## Technical change to RJ45 CabinetLine

- PCN-number: PCN-PB47-20180213-00-A
- date of publishing: 13<sup>th</sup> of February 2018 / Update 18<sup>th</sup> of June 2018
- revision number: B

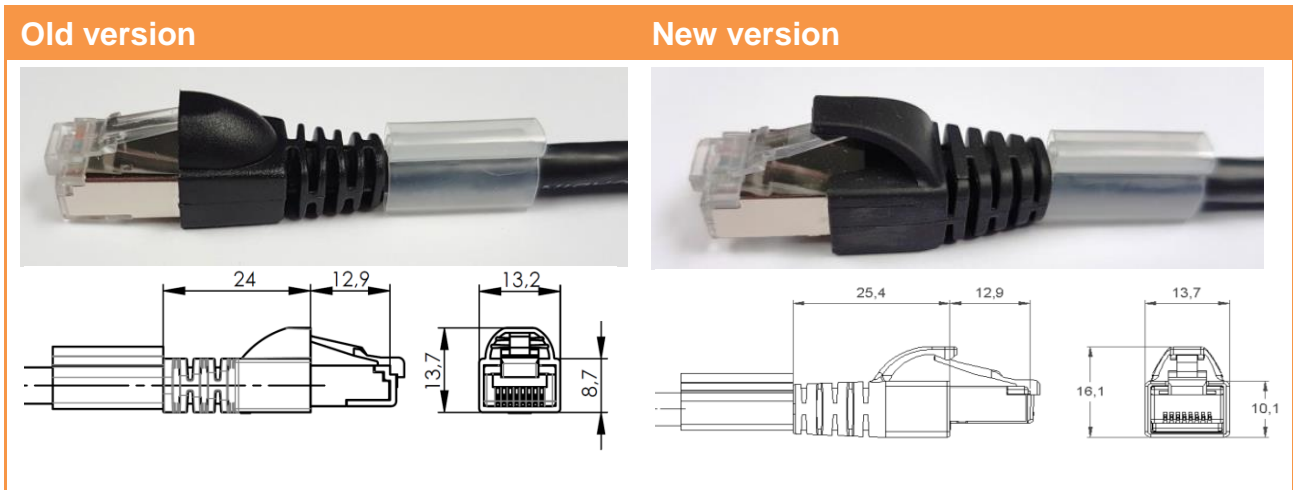
- The RJ45 connector moulding has a new design and material (PUR).
- Furthermore, we added cable printing for a better identification after installation of the patch cord.
- With regard to the technical requirements the new CabinetLine meets the same tests as the old version.
- Furthermore color deviations may occur.

Improve the handling of the latch protection especially by low temperatures.
